RE: Proposal to erect club house at Cornerpark, Newcastle for
St. Finians G.A.A.

Development : Erect club house
LOCATION : Cornerpark, Newcastle
Applicant : St. Finians G.A.A.
App. Type : PERMISSION
Planning Officer : M.GALVIN
Date Recd. : 10th December 1991

Decision Order Number : P/ 0492 /92 Date of Decision : 6th February 1992
Register Reference : 91A/1946 Date Received : 10th December 1991
Applicant : St. Finians G.A.A.
Development : Erect club house
Location : cornerpark, Newcastle

PROPOSED LAY-OUT.

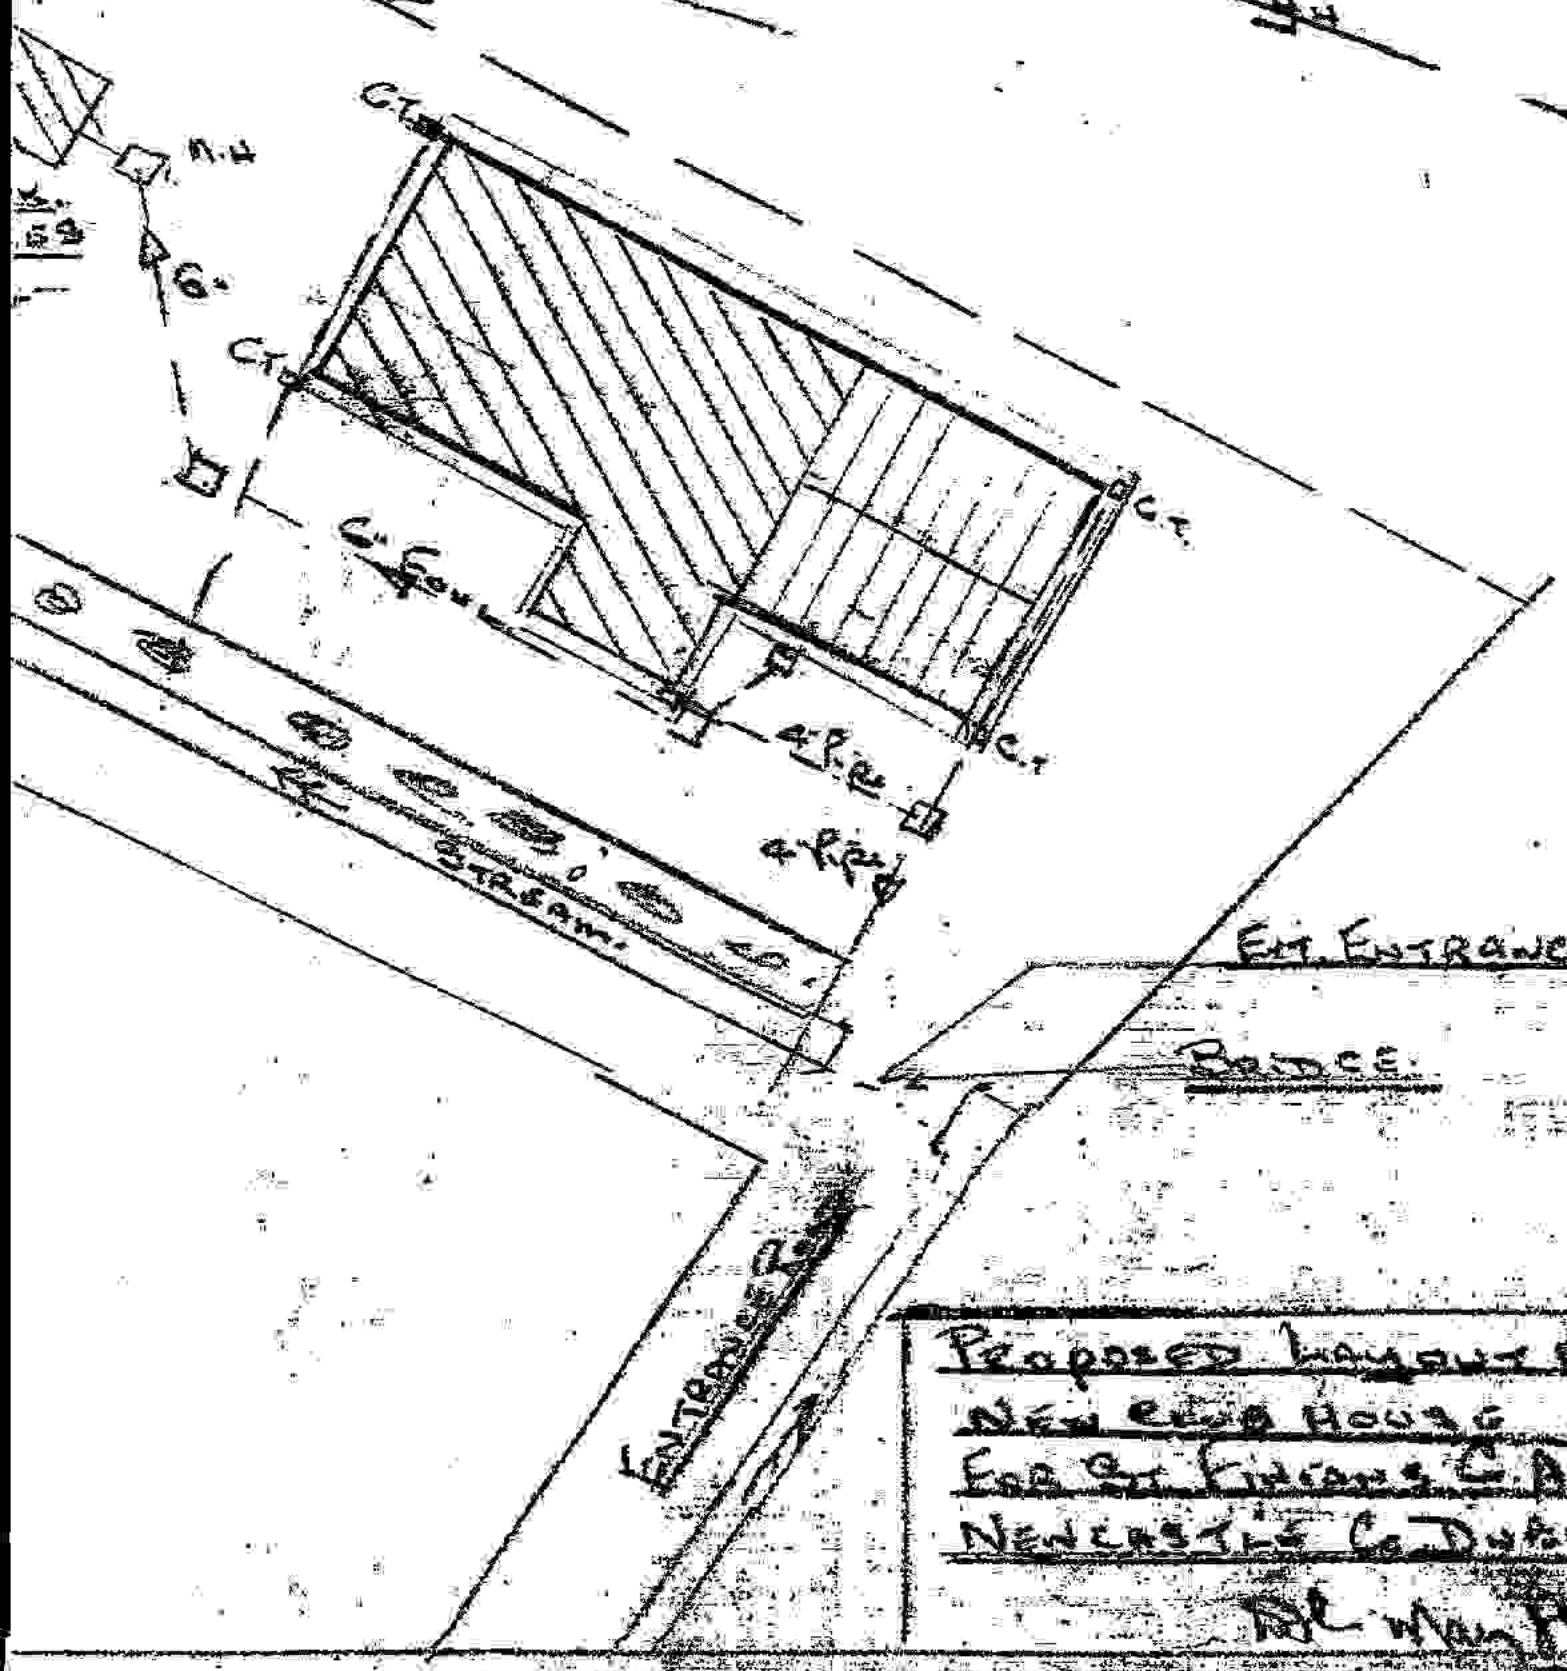
- ① Applicant is requested to clearly identify all of the elements in the proposed system & to indicate their layout & location on a suitably scaled drawing.
- ② Applicant is requested to establish the size of percolation area required, tend to demonstrate by way of a dimensioned drawing (all elements to be fully dimensioned) that all elements of the treatment process can be properly accommodated as proposed in the location proposed
- ③ Applicant is requested to draw a cross section through the site to include ~~SURFACE WATER~~ the end wall of the clubhouse, each element of the treatment process and the stream.

Note: ① No effluent will be allowed discharge to the stream, directly or indirectly
② Septic tank involved in process — refer to E.H.B.
